# Coastal Rail Trail Segments 10 and 11 Final Environmental Impact Report

Volume 1: Comments and Responses on the Draft EIR

**County of Santa Cruz**

**March 2024**

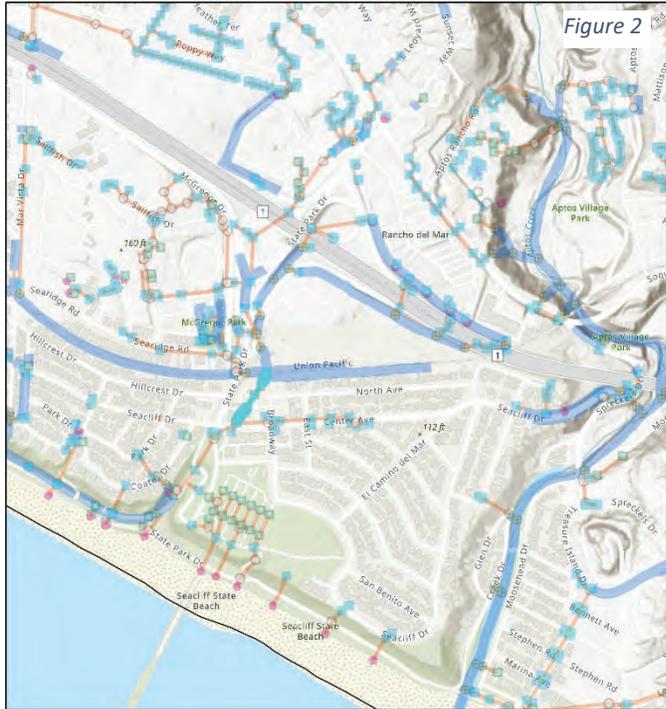
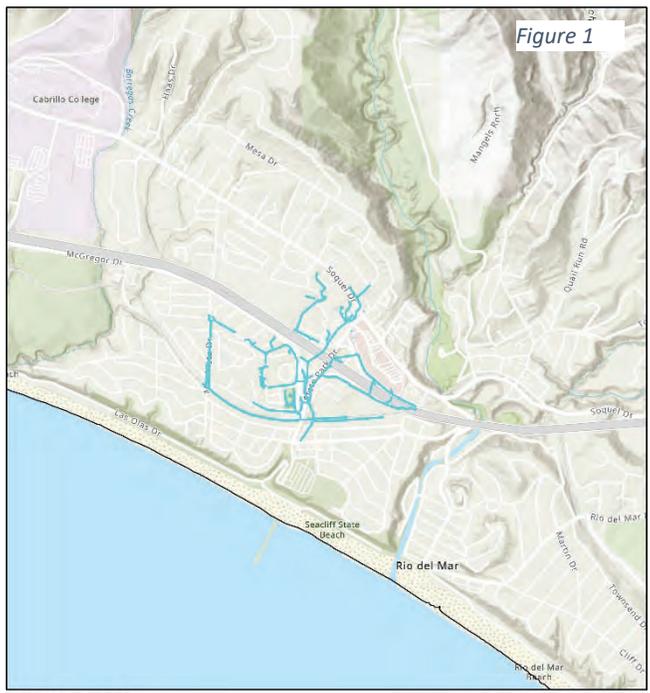
There is an inadequate drainage facility running through our town which is significantly fed by the areas where this project work will be done. This facility routinely floods and generates a severe current and sump which erodes and poses a risk to life if a person should fall or be swept into the channel. The channel crosses private lands through a county easement that has long since overflowed its bounds. In addition to the direct effects of the work both while underway and more importantly after completion, the additional rail trail facility exposes our members and our community to a terrible risk from an open stormwater channel. We need only reflect on the terrible loss of 5-year-old Kyle Doan near Paso Robles last winter to recognize that this problem must not be ignored. A responsible assessment of impacts of the project work should include addressing and/or undergrounding the stormwater channel in Seacliff between the railroad and Center Ave parallel to State Park Drive. We ask that the impact report consider and address this problem in its findings and recommendations.

EIR analysis: The EIR does not adequately address the consequences of this project alone or with related or concurrent projects and problematic conditions associated with an apparently unconsidered aspect of the stormwater facilities affected by the project(s). We are expressing grave concern about the adequacy of the structures (or lack thereof) that occur between the rail line and Center Ave in Seacliff (highlighted in Figure 1 in light blue below). The drainage lines highlighted in Figure 2 show the areas draining through the highlighted flow in Figure 1.

stormwater flow through the drainage section in Figure 1 have not been responsibly calculated and considered.
